# SOUTH END STATION AREA PLAN

Plan Amendments  
Draft October 2017

SOUTH END TRANSIT STATION AREA PLAN

*E. Kingston Ave: South End street with "Adequate Width"*

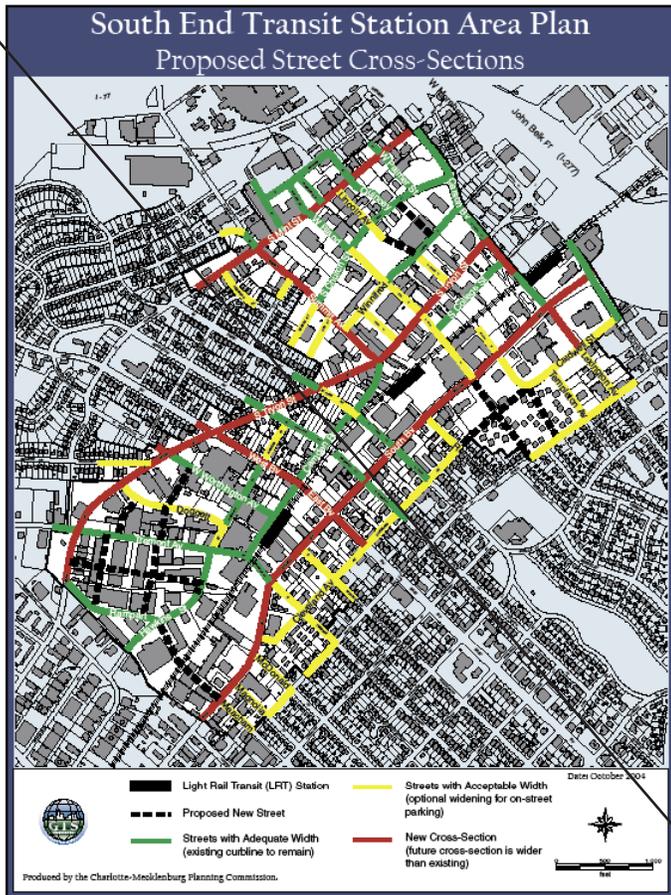
Eliminated paragraph due to elimination of diagram on Page 25

Eliminated end of caption due to elimination of diagram on Page 25

**Proposed Future Cross Section - Interim  
S. Tryon St. (Carson Boulevard to Tremont Avenue)**

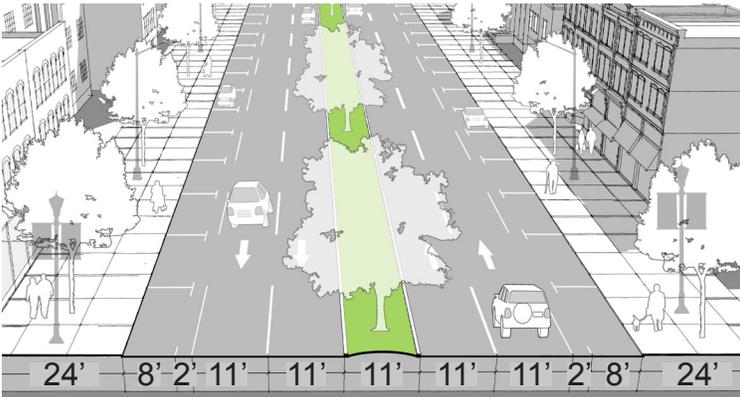
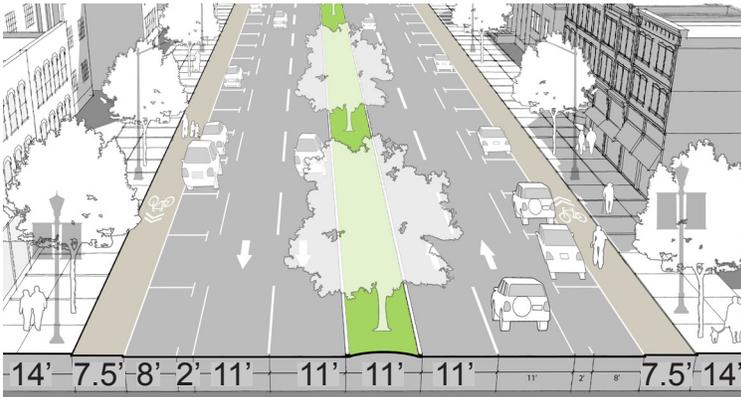
**Proposed Future Cross Section - Final  
S. Tryon St. (Carson Boulevard to Tremont Avenue)**

**Proposed Future Cross Section - Interim  
S. Tryon St. (Tremont Avenue to Clanton Drive)**

**Proposed Future Cross Section - Final  
S. Tryon St. (Tremont Avenue to Clanton Drive)**

Proposed Future Cross Section - Interim  
South Boulevard (Carson Boulevard to Iverson Way)

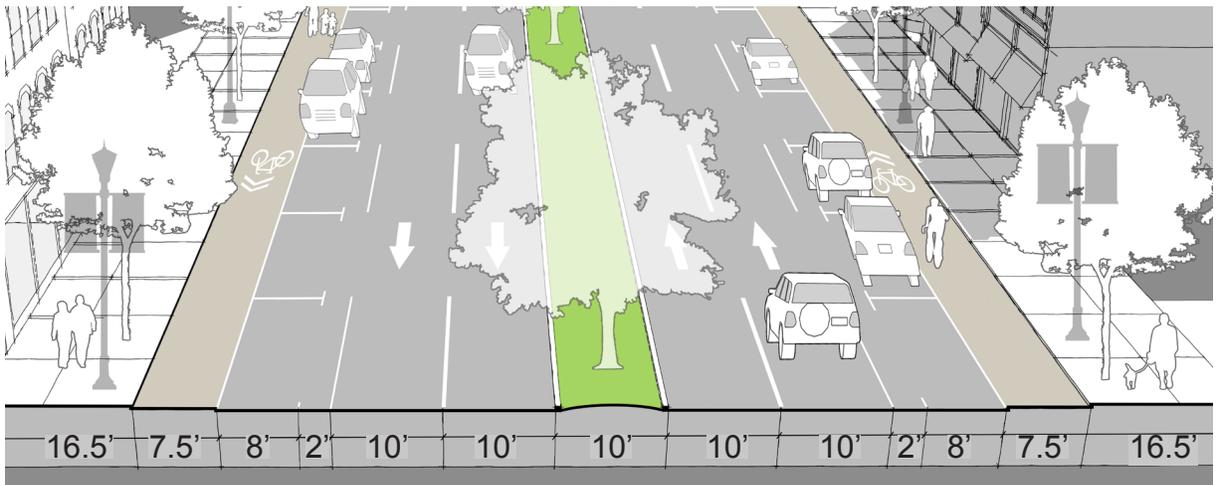
Proposed Future Cross Section - Final  
South Boulevard (Carson Boulevard to Iverson Way)
